31. MAC Control

Draft 0.1, March 2005 Initial draft for FE Task Force review.

Figure 31 –2—MAC Control sublayer support of interlayer service interfaces

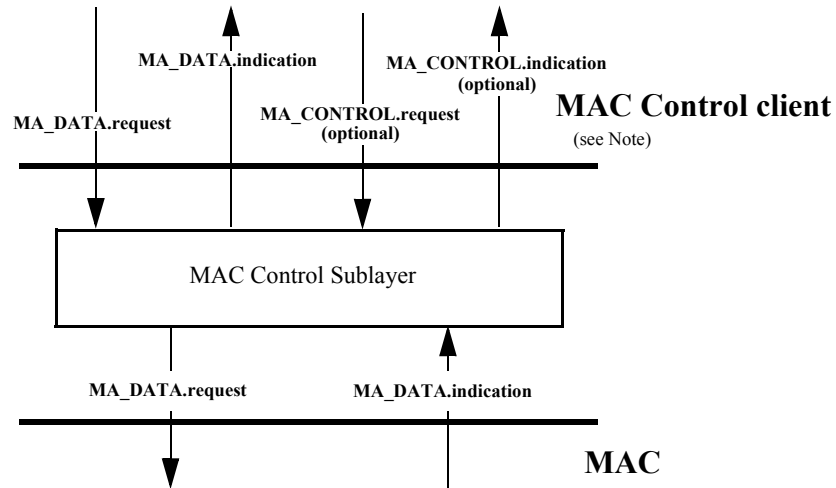
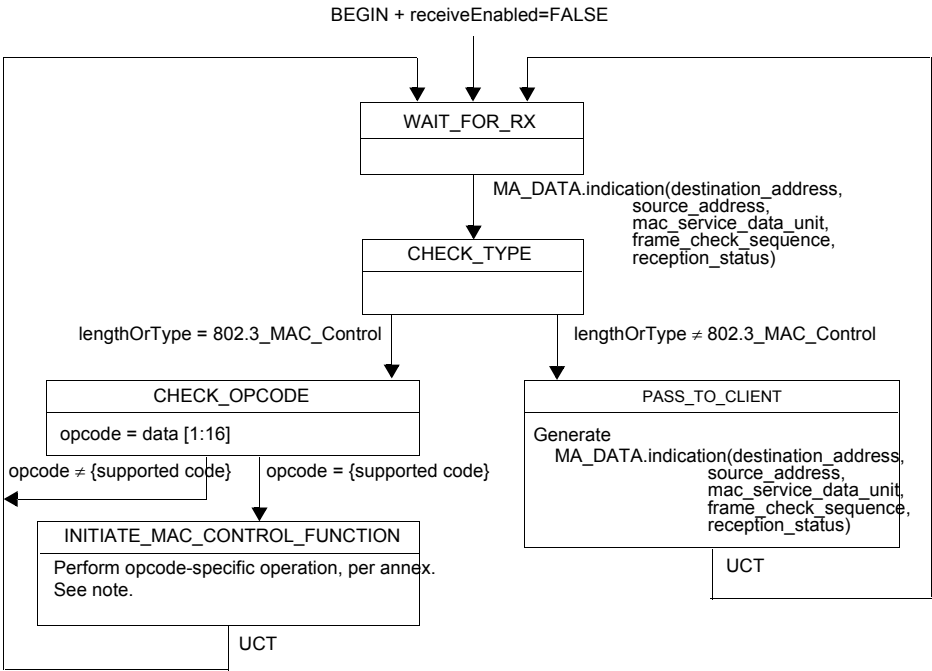
Figure 31-2 is changed as shown below.

Figure 31B-1—PAUSE Operation Transmit state diagram

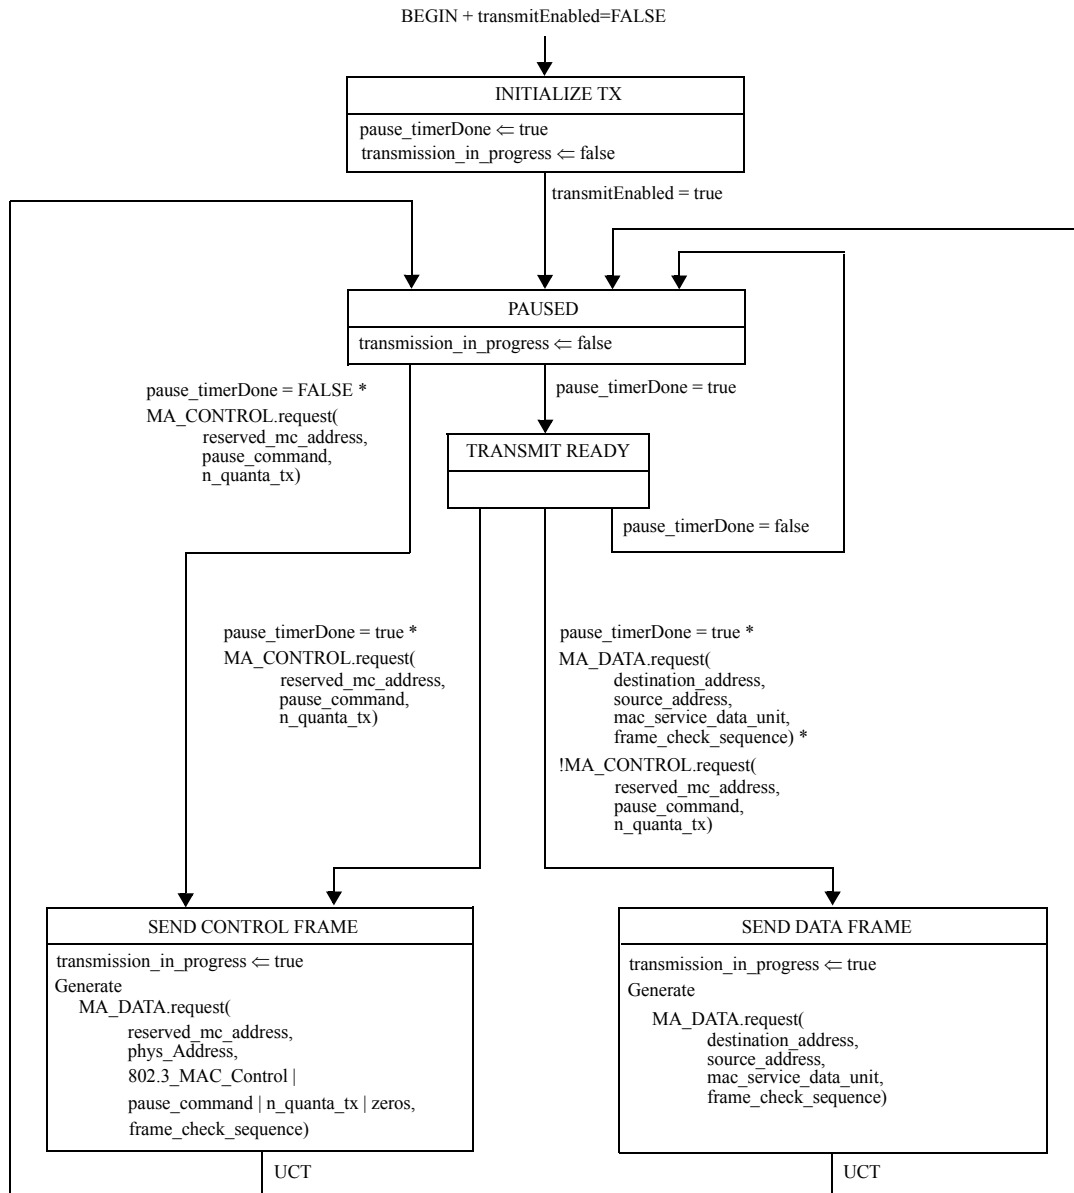
Figure 31B-1 is changed as shown below:
